RE: HARLOW STAGE 7 - AMENDMENTS TO CONSTRUCTION PLAN APPROVAL

RE: HARLOW STAGE 7 - CONSTRUCTION PLAN APPROVAL

**HARLOW ESTATE
STAGE 7
ROAD AND DRAINAGE
FACE SHEET**
WYNDHAM CITY COUNCIL
SIG GROUP

**HARLOW ESTATE
STAGE 7
ROAD AND DRAINAGE
FACE PLAN
WYNDHAM CITY COUNCIL
SIG GROUP**

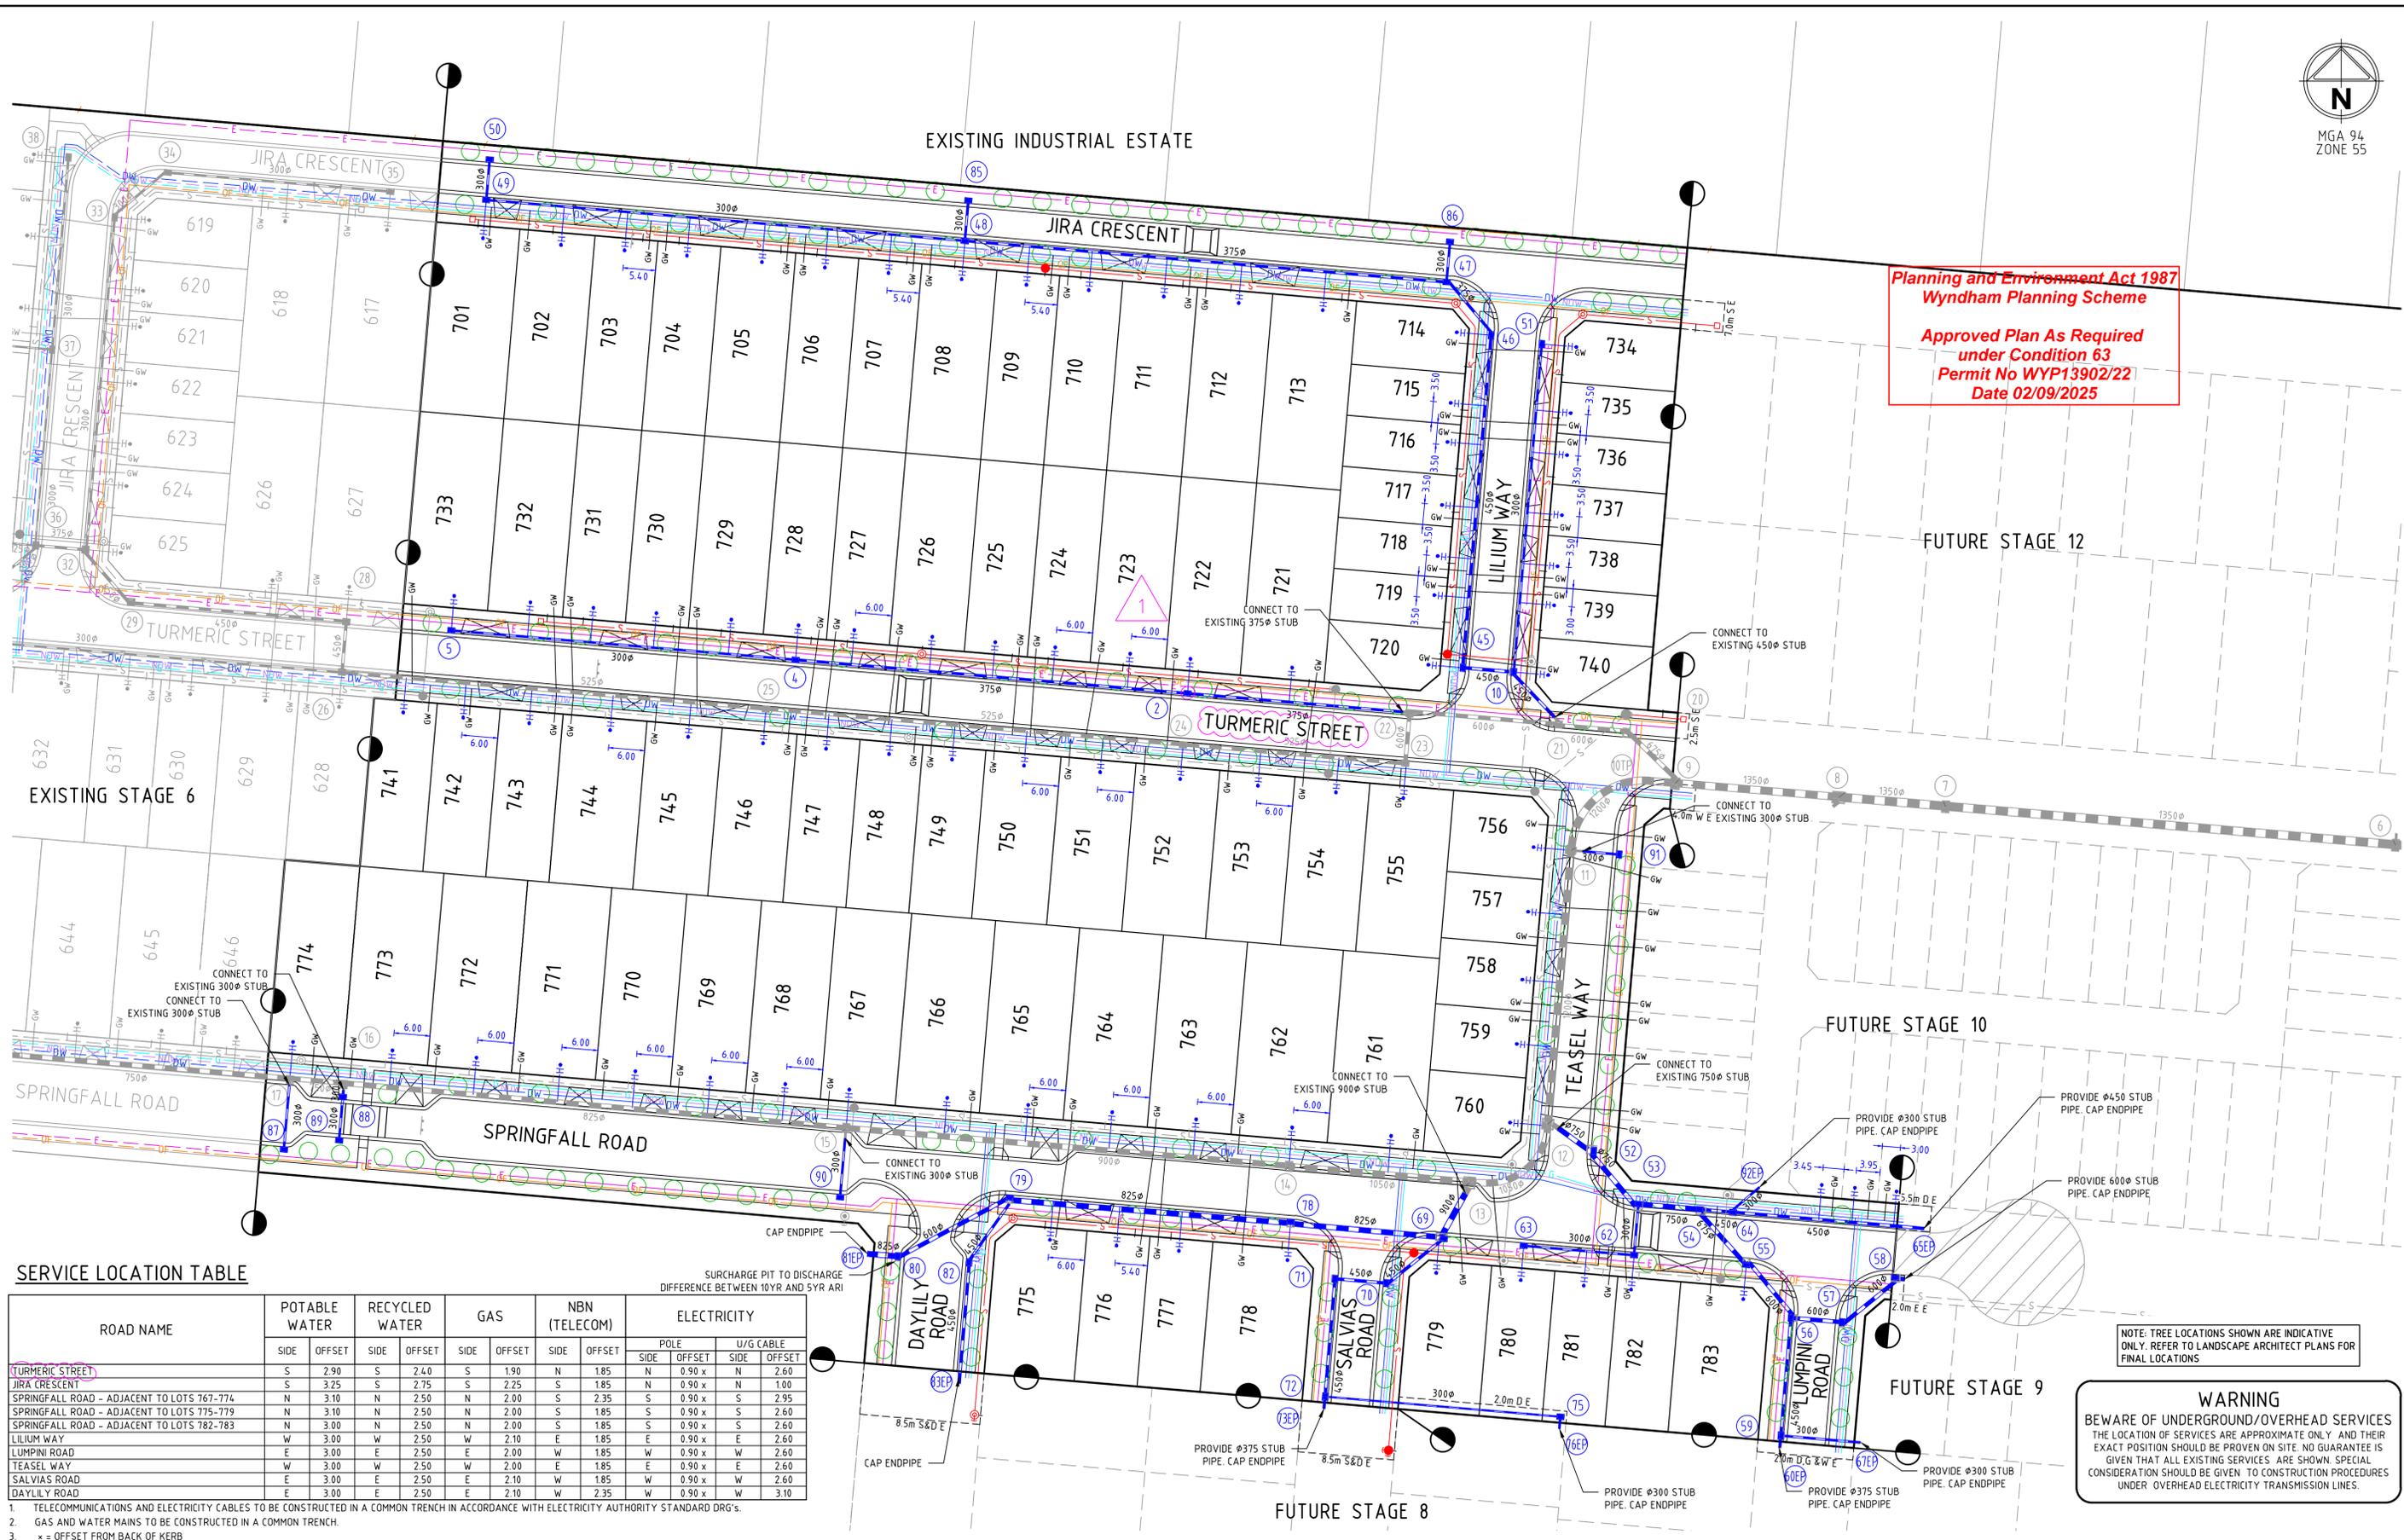
- **Road name changed from “Bournside St” to “Turmeric St”.**
- **Minor Pits amended for 10,59,69 & 72.**
- **Ramp for Raised Pavement change to 1.2m.**

Rev	Amendments	Approved	Date
1	ROAD NAME AND PIT 2 SIZE AMENDED	G.K	21/08/25
0	ISSUED FOR CONSTRUCTION	G.K	29/07/25
B	HOUSE DRAINS AMENDED & ADDED	G.K	30/05/25
A	ISSUED TO COUNCIL	G.K	04/04/25

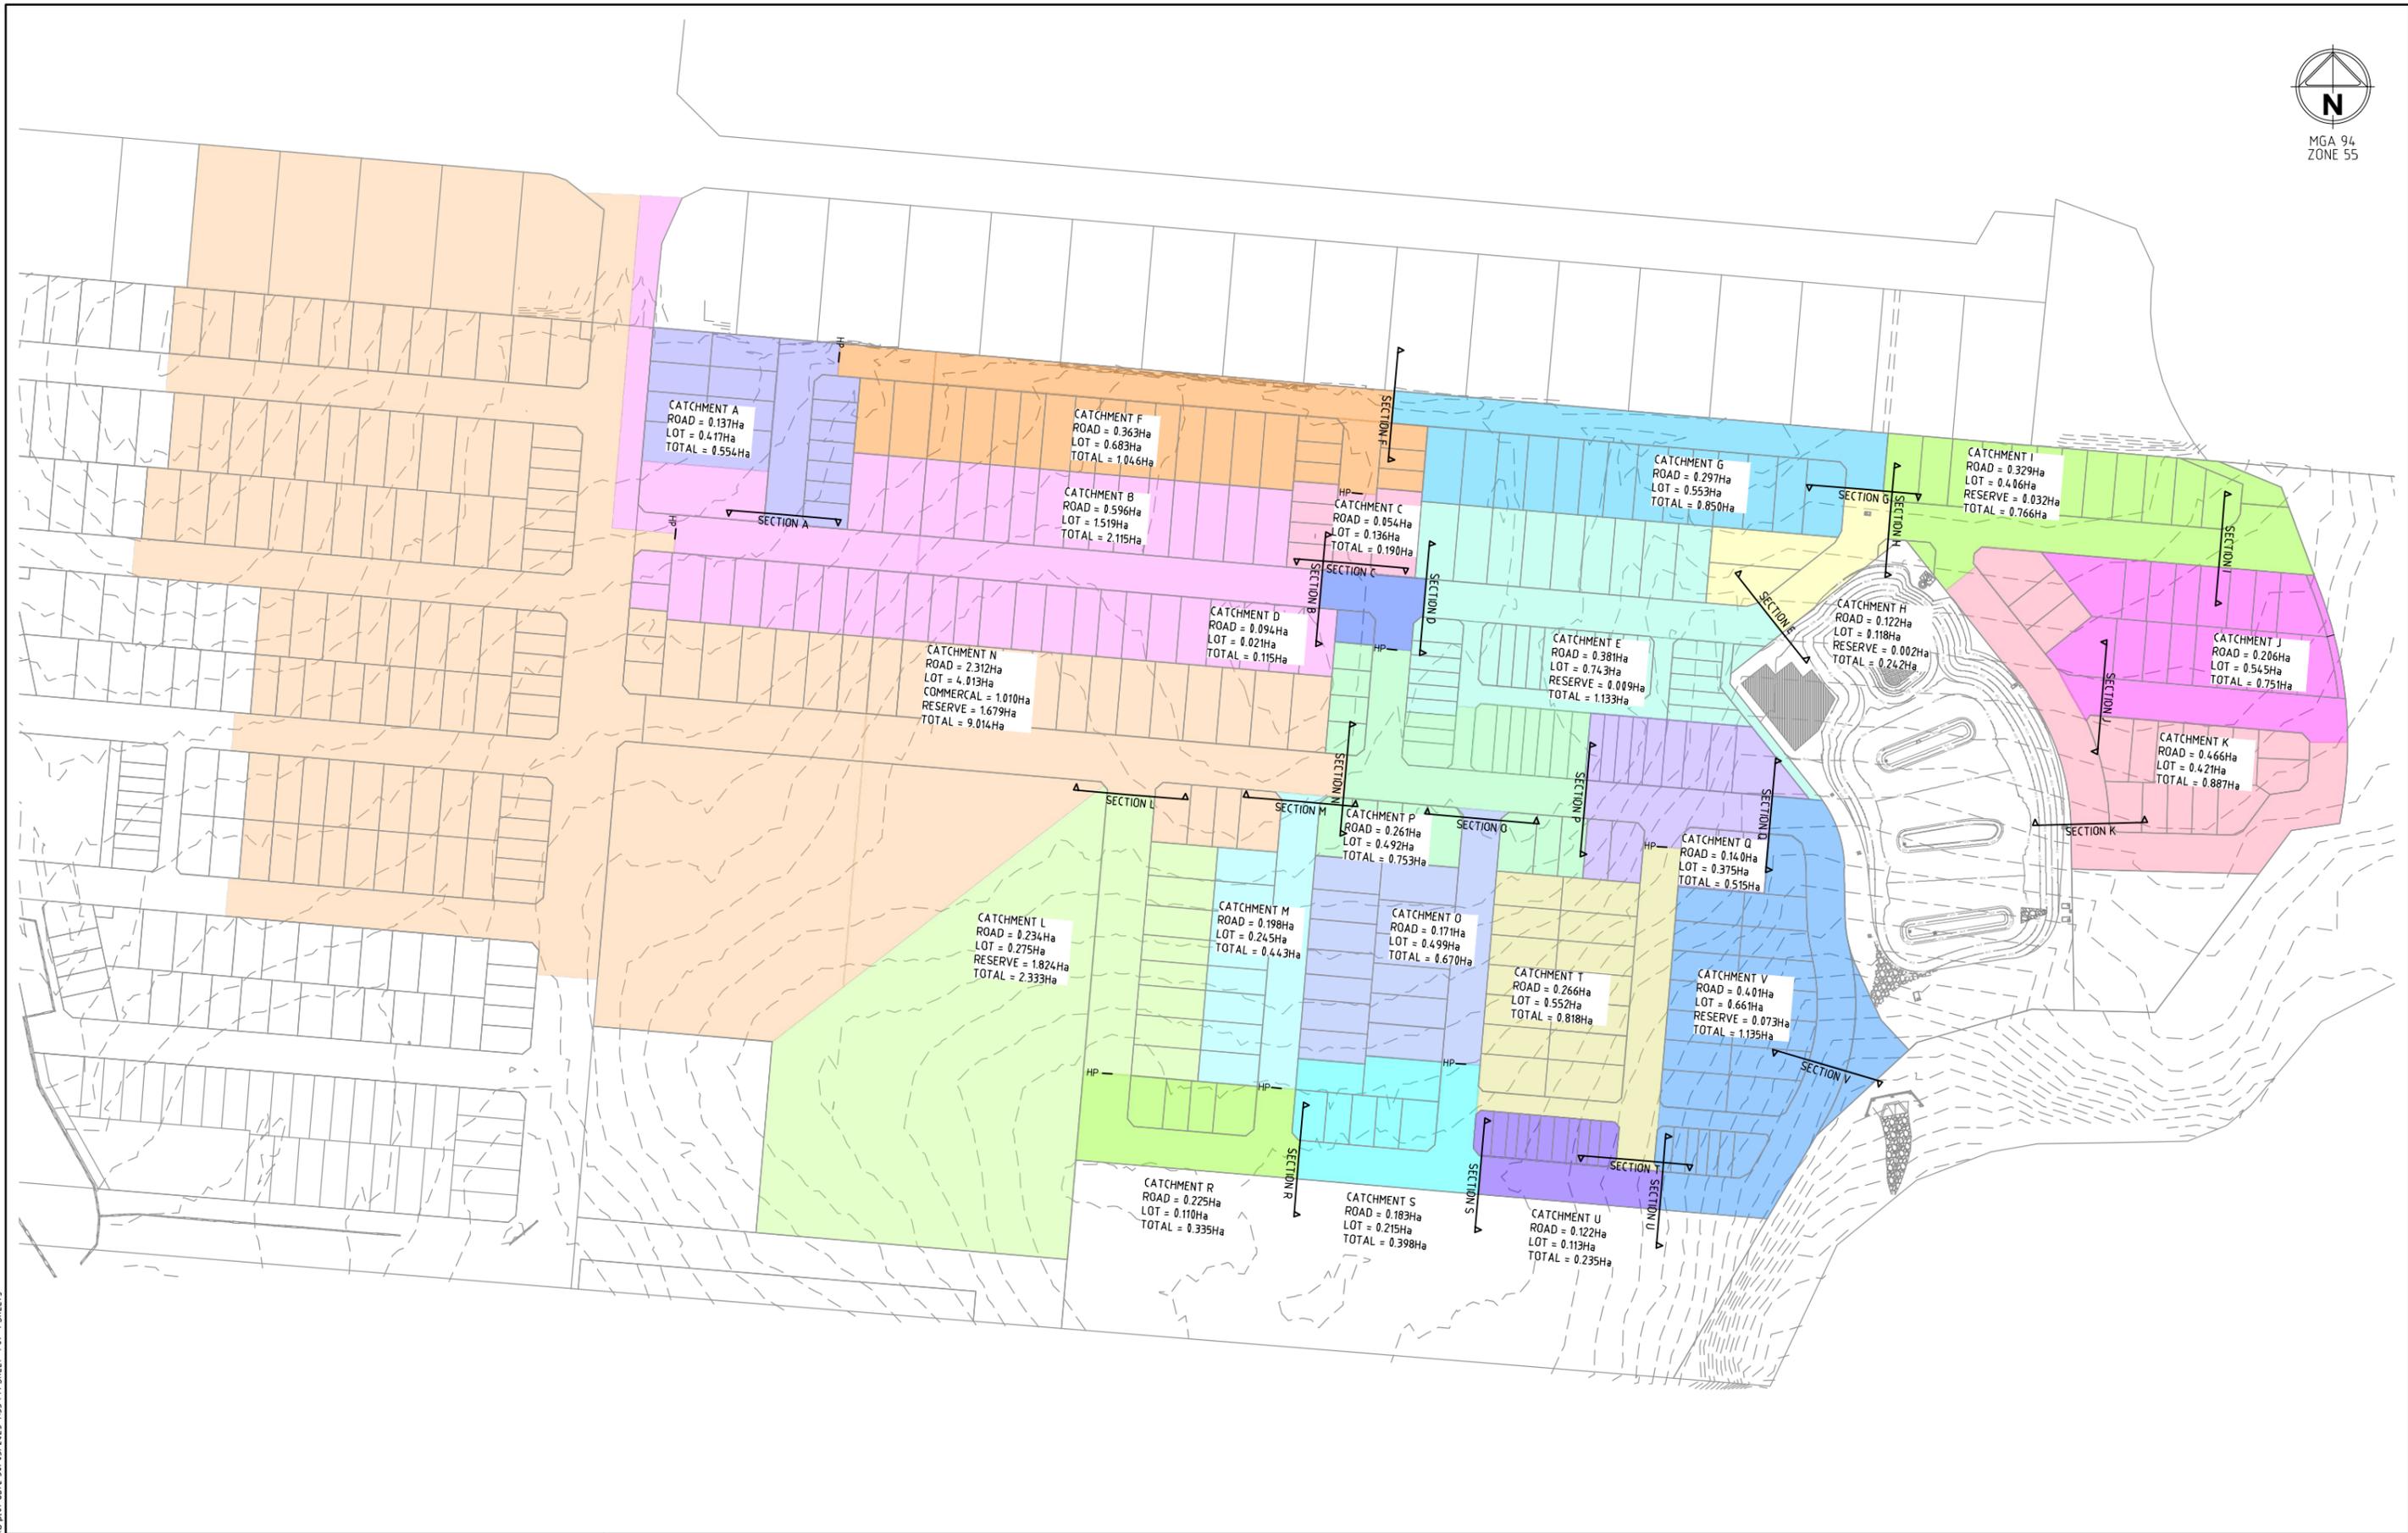
Rev	Amendments	Approved	Date
1	ROAD NAME AMENDED	G.K	21/08/25
0	ISSUED FOR CONSTRUCTION	G.K	29/07/25
B	SIGNAGE REMOVED, AMENDED & ADDED	G.K	30/05/25
A	ISSUED TO COUNCIL	G.K	04/04/25
